TAKE 5 OIL CHANGE

AT 820 PANTOPS CORNER WAY

ARB FINAL SUBMISSION #1
SEPTEMBER 7th, 2021

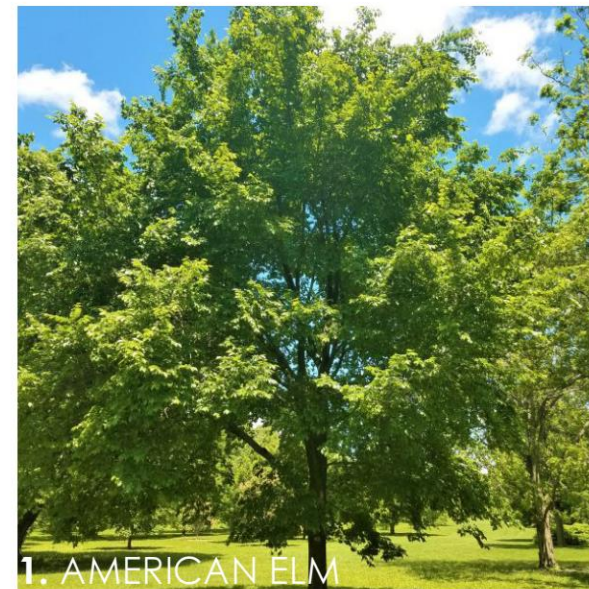
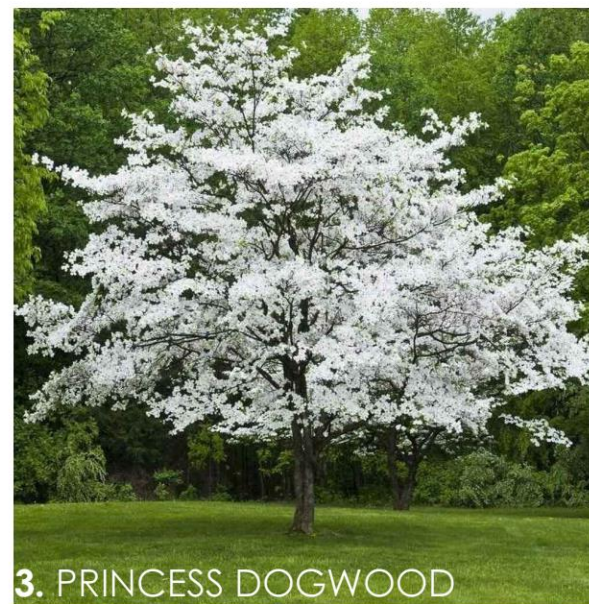
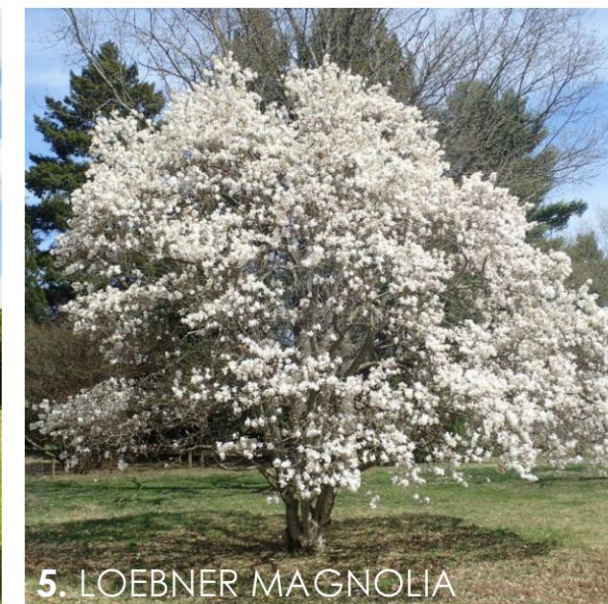
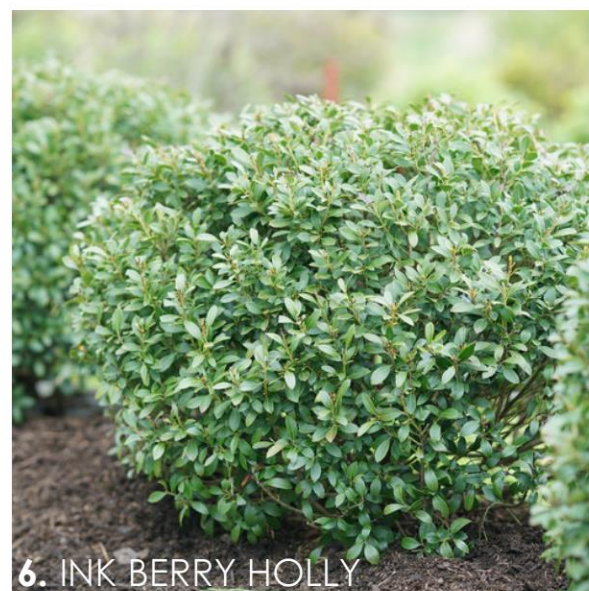
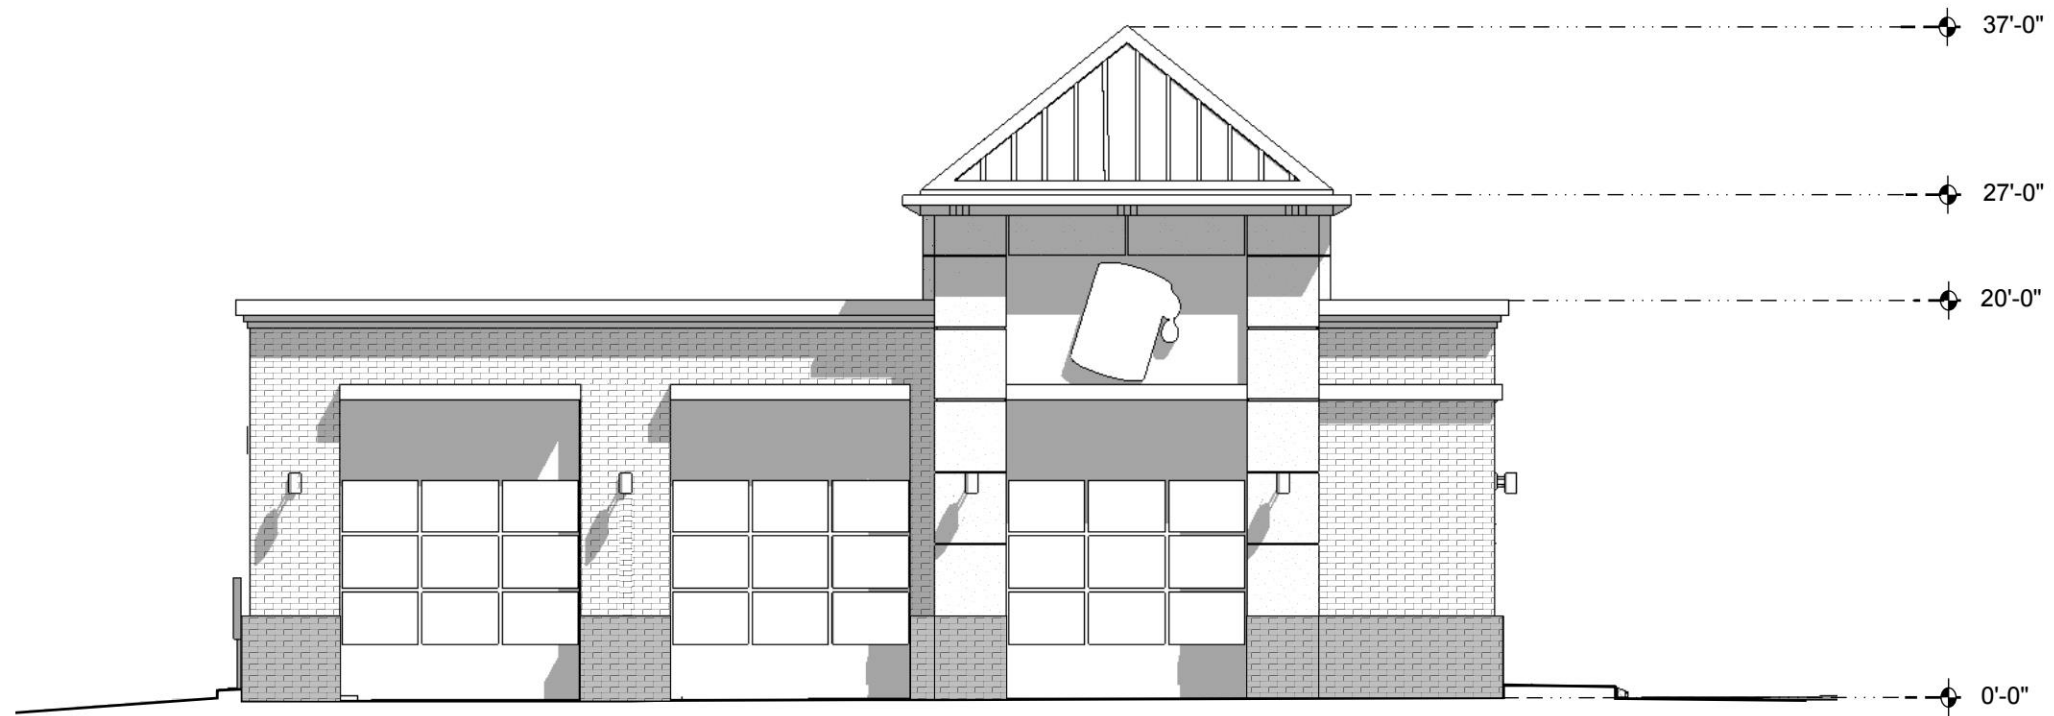
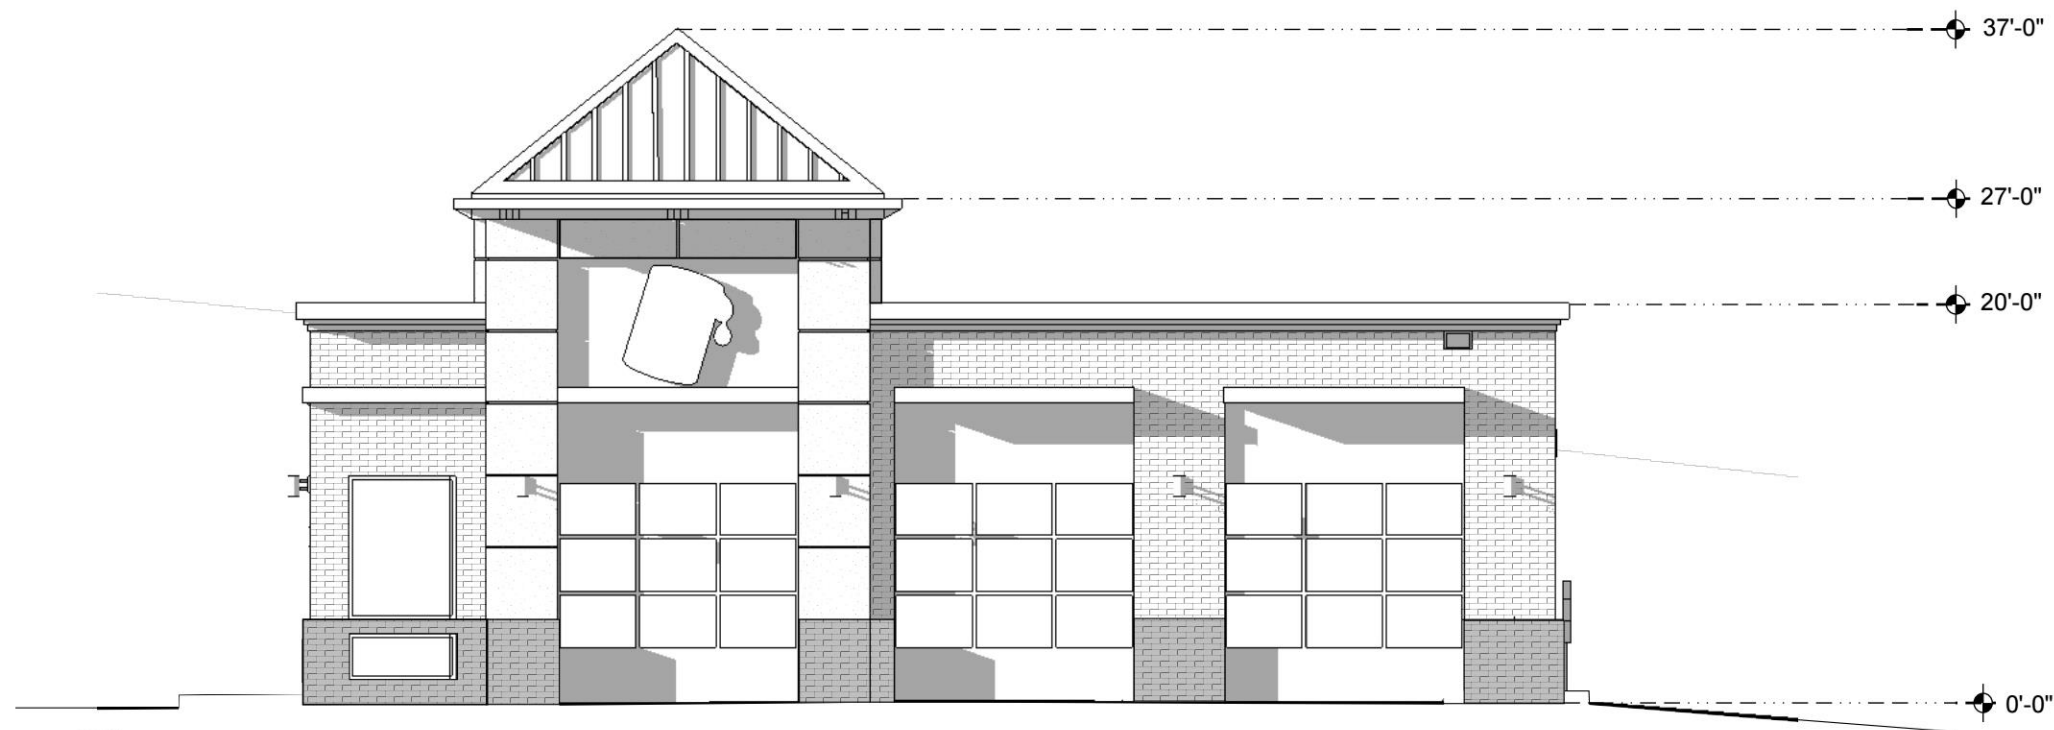
7. Revise the plan to provide trees at 3.5" caliper at the time of planting along the Rt. 250 frontage.

8. Revise the landscape plan to shift the row of shrubs along the frontage so that it is within the parcel boundaries.

B 10. Consider adding a landscape island along the east end of the building between the building and adjacent travel lane.

Response: 3.5" caliper large deciduous trees have been specified along the Route 250 frontage.

Response: The shrubs have been shifted 12" to remain clearly within the parcel.

Response: Two landscape islands have been added to the east end of the building on the north and south facades. Please note we did not extend the islands into the adjacent travel aisle to avoid a pedestrian having to walk into the travel aisle to access the waiting room entrance, but have added two ornamental flowering trees and ground cover at each island.

FRONT ELEVATION
14

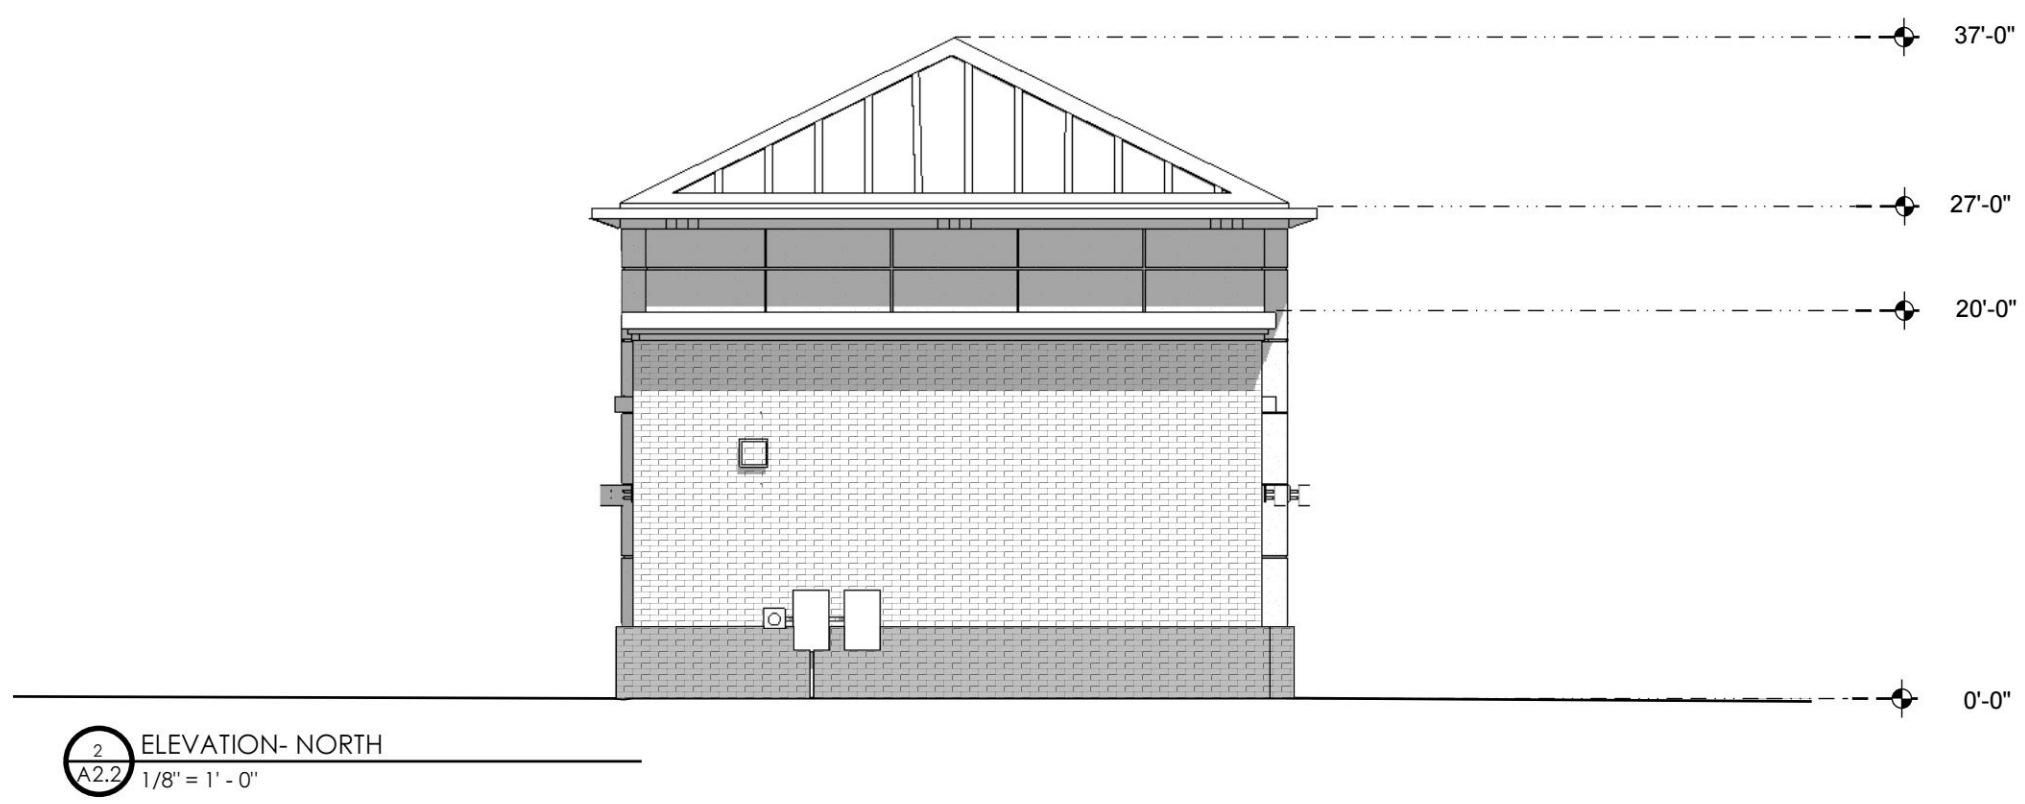
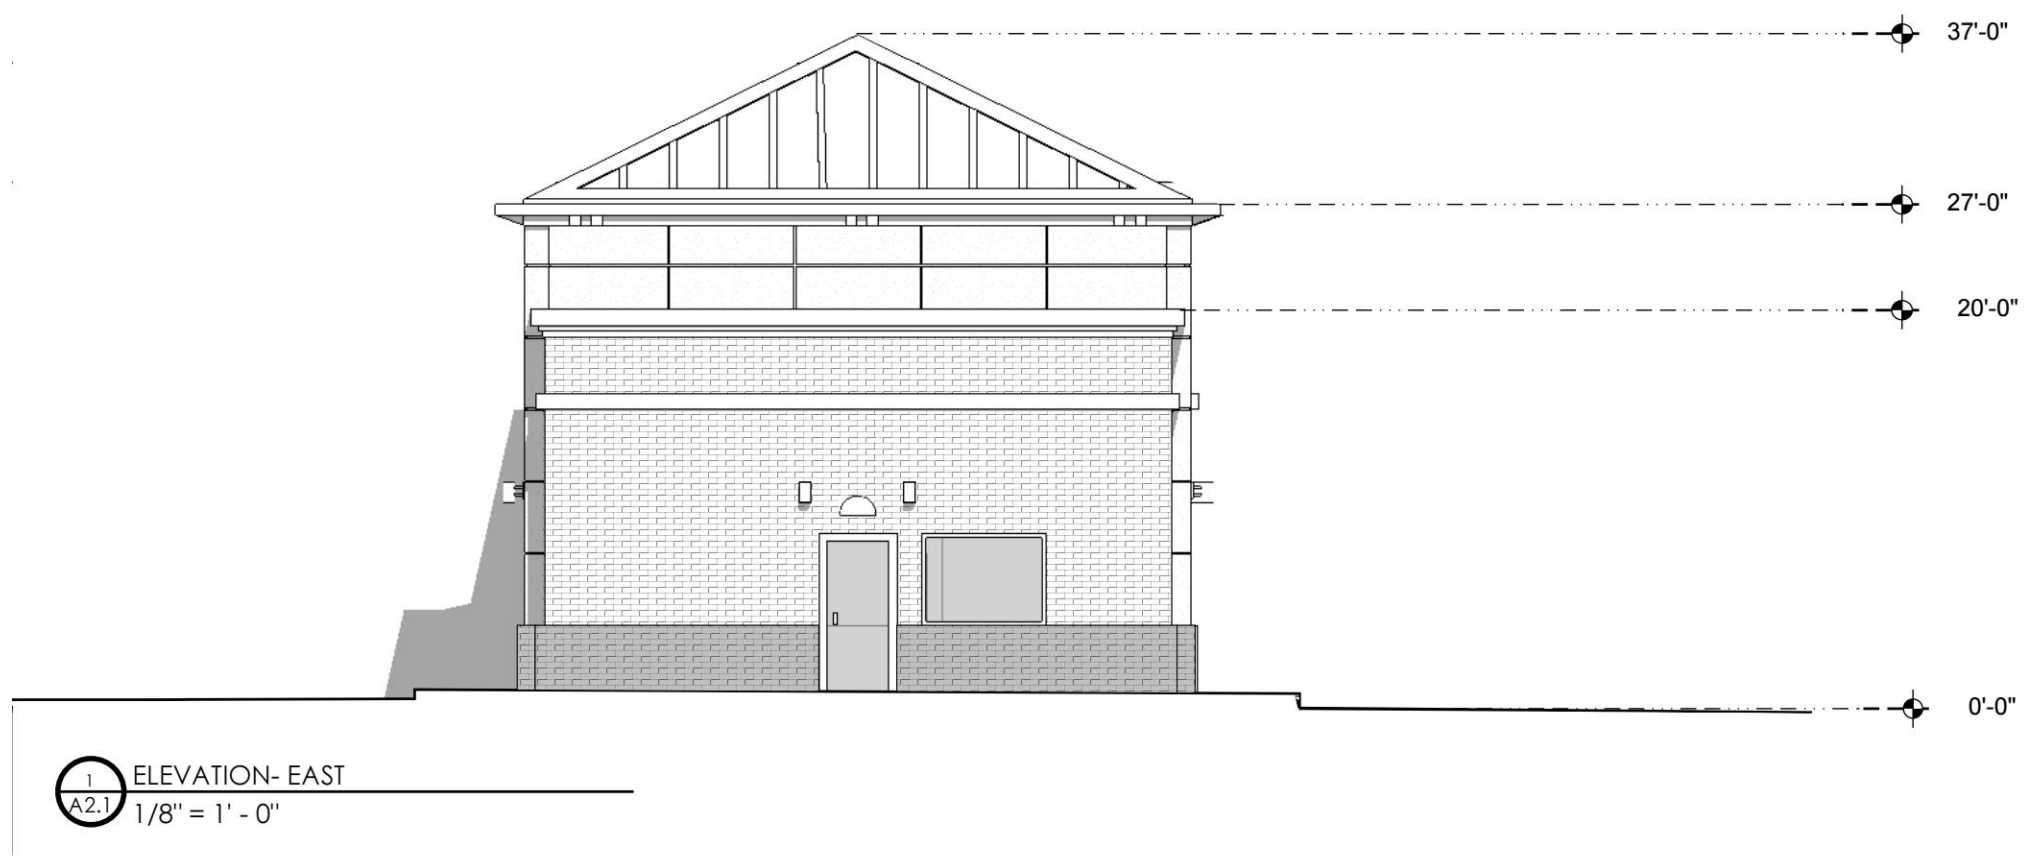
A 2. Revise the mix of wall materials to make brick the primary building material. Thin brick is acceptable provided that the corners appear as full dimensional brick.

3. Revise the architectural drawings to include the standard window glass note: Visible light transmittance (VLT) shall not drop below 40%. Visible light reflectance (VLR) shall not exceed 30%.

Response: The facade has been revised to incorporate brick as the primary building material. The base of the building remains as a full brick dimension Glen-Gery Utility-sized brick in "Carbon Black" with Workrite Mortar in "WR-2062 Smoke" color. The main body of the building has been revised from EIFS to Glen-Gery thin brick "Feldhaus 800 Classic Gray Smooth" with Workrite Mortar in "WR 2055 Gravel" color. The tower element remains in EIFS painted "Ellie Gray" to establish a visual hierarchy and distinguish the tower element, whose facade remains proud of the base and body of the structure.

Response: The following standard note has been added to the architectural drawings: "Windows will not be highly tinted or highly reflective. Visible light transmittance shall not drop below 40% and visible light reflectance shall not exceed 30%."
